Gachsaran Polymer Industries Company	Gachsaran Polymer Industries Company HDPE Plant		
	General Arrangement Drawing (2D) (*Tie-In Points , Skid Dimensions & Orientation, Including Instrument, Junction Box and Local Panel Location Layout & Instrument Cable routing.) for Refrigerator Package	 	
PO No.: GPIC-PT-MA-PO-000-3029	Document Number: VD-GPIC-MA-3029-3029-0062	Rev. 00	Page 1 of 11

General Arrangement Drawing (2D) (*Tie-In Points , Skid Dimensions & Orientation, Including Instrument, Junction Box and Local Panel Location Layout & Instrument Cable routing.) for Refrigerator Package

FRONT VIEW

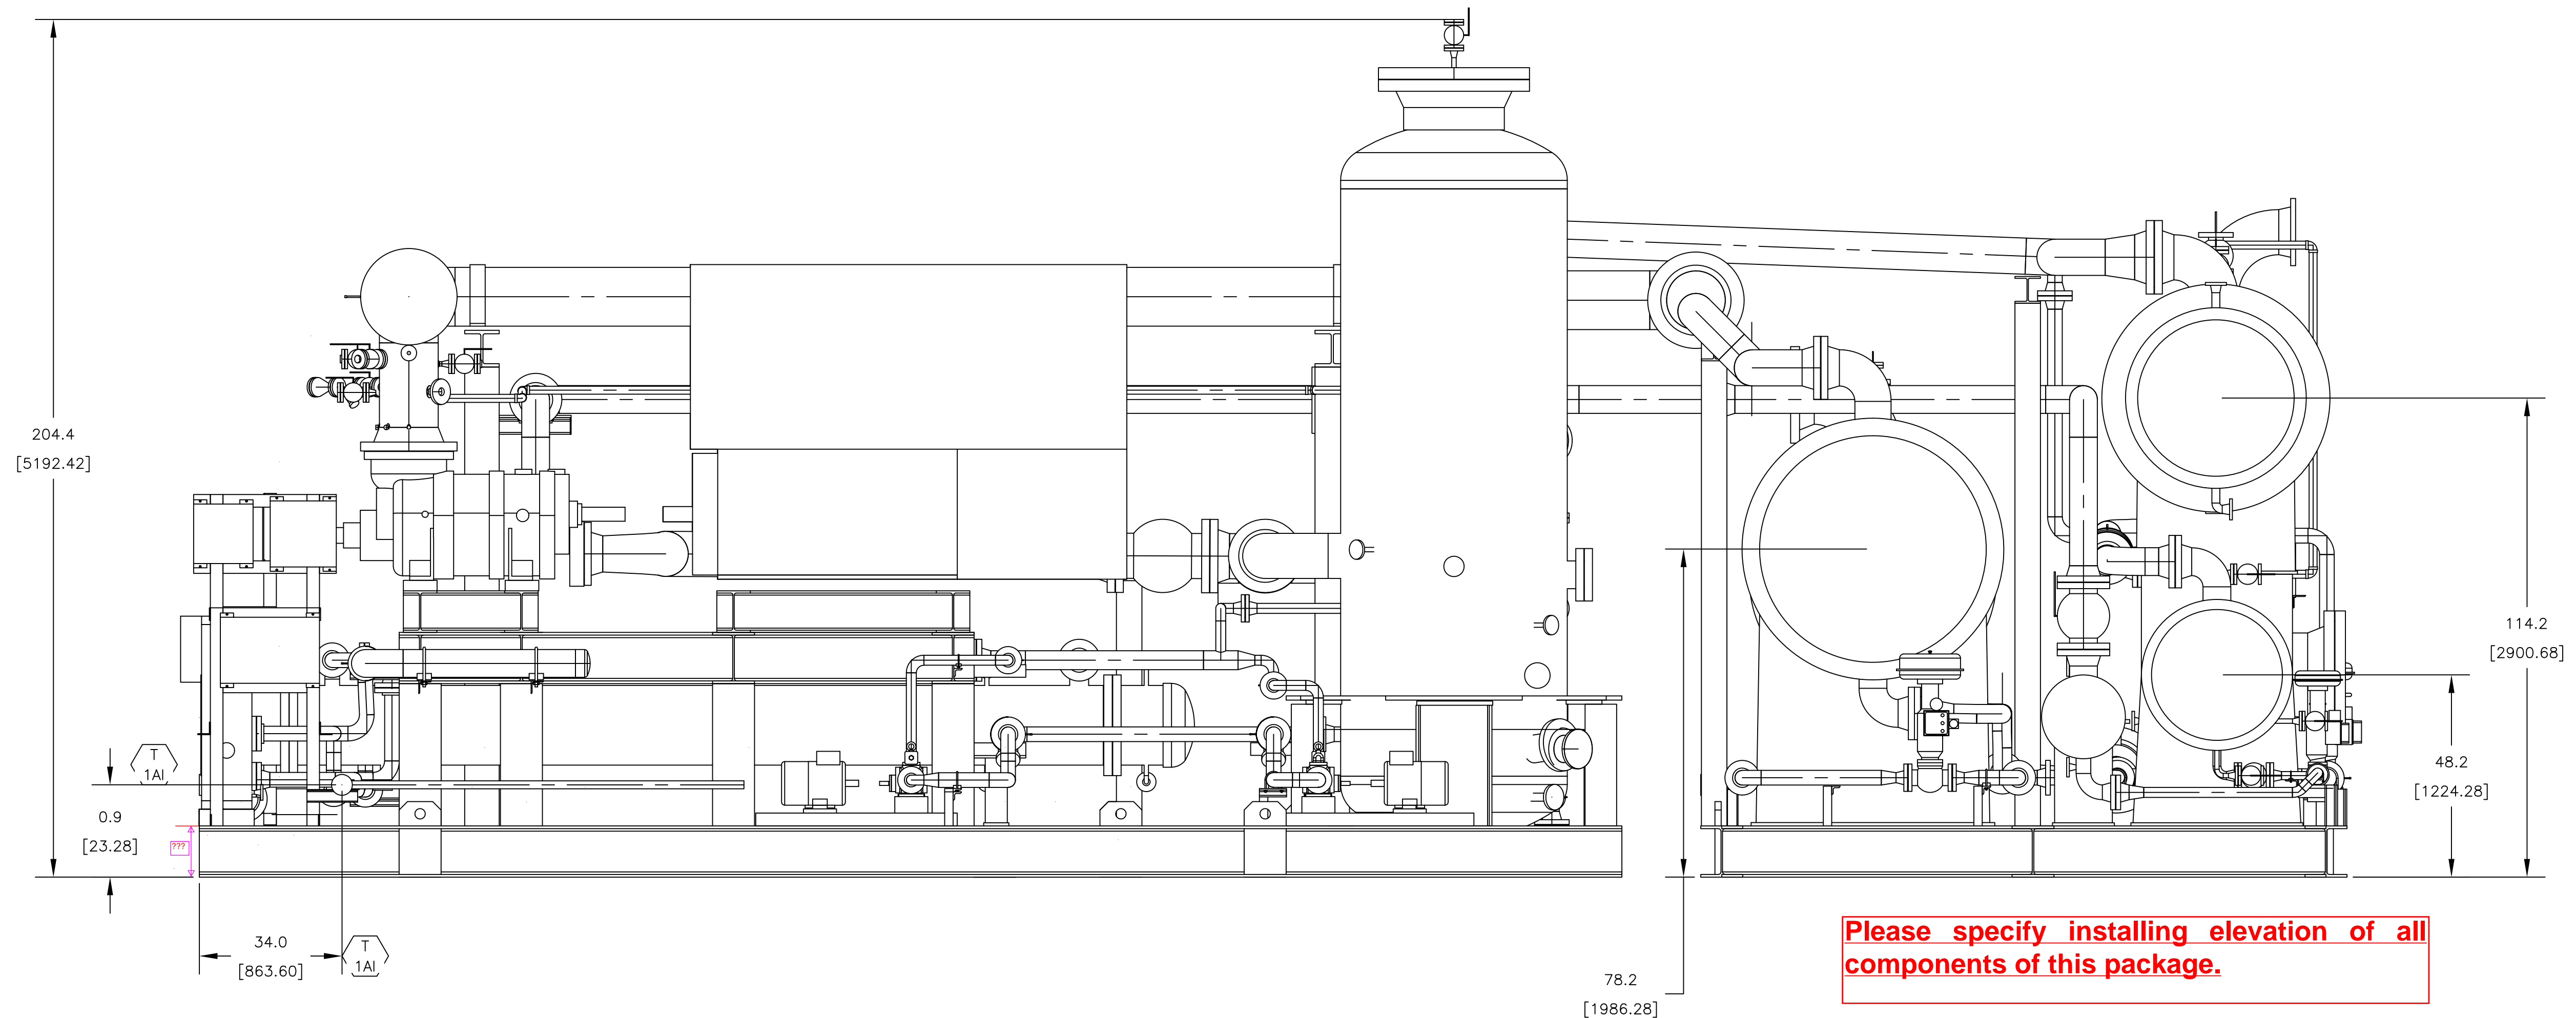
PI-01:

1- Displacement and allowable loads at tie-in points shall be specified by vendor. Table of Allowable nozzle loads shall be add for tie-in points.

2- Isometric of piping inside package including supports type(rest, Guide , Stop) and position, shall be provided by vendor.

- Furthermore, fixed(anchor) supports shall be considered at tie-ins with EIED in order to separating scope of work.

3- Stress Analysis Report including Caesar II native files for critical pipes inside package shall be provided by vendor.

4- Expansion joints data sheet (including type, spring rate and etc.) shall be provided by vendor. (if required)

EL02: Local Panel and junction boxes shall be numbered and displayed in a table with tags.
